OAK GROVE SUBDIVISION

The purpose of this application is to subdivide a large metes and bounds parcel into 119 lots.

DETAIL SITE PLAN

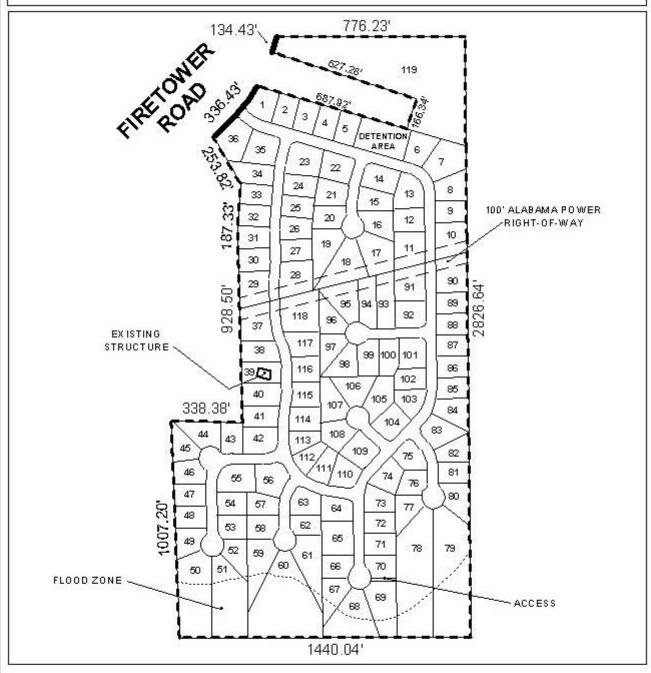
As a means of access management, a note should be placed on the final plat stating that Lots 1 and 36 are denied direct access to Firetower Road. Additionally, there are many corner lots, and a note should be placed on the final plat stating that lots located on a corner (Lots 14, 22, 23, 35, 42, 55, 56, 63, 64, 75, 83, 92, 101, 104, 109 and 110) are allowed one curb cut each, with the design, size and location to be approved by County Engineering.

The proposed layout creates long "straight a ways", therefore, traffic calming devices (traffic circles) should be provided in the area of Lots 10, 11, 28 and 29. Furthermore, no provision is made for connectivity with adjoining properties, and based upon the Vicinity Map, the adjoining properties are ripe for subdivision. Therefore, the provision of street stubs to the East and West, in the Vicinity of the Alabama Power easement, should be required.

A detention area is shown on the plat, thus the placement of a note on the final plat stating that maintenance of the detention area shall be the responsibility of the property owners, should be required.

The 25-foot minimum setback lines are not shown but would be required on the final plat.

With modifications, the plat meets the minimum requirements of the Subdivision Regulations and is recommended for Tentative Approval subject to the following conditions: 1) the placement of a note should on the final plat stating that Lots 1 and 36 are denied direct access to Firetower Road; 2) the placement of a note should on the final plat stating that corner lots (Lots 14, 22, 23, 35, 42, 55, 56, 63, 64, 75, 83, 92, 101, 104, 109 and 110) are limited to one curb cut each, with the design, size and location to be approved by County Engineering; 3) the provision of traffic circles in the area of Lots 10, 11, 28 and 29; 4) the provision of street stubs to the East and West in the vicinity of the Alabama Power easement; 5) the detention area be indicated on the final plat with a note stating that the maintenance thereof is the responsibility of the property owners association; 6) the placement of a note on the final plat stating that any lots which are developed commercially and adjoin residentially developed property must provide a buffer, in compliance with Section V.A.7. of the Subdivision Regulations; and 7) the placement of the 25-foot minimum setback lines on the final plat.
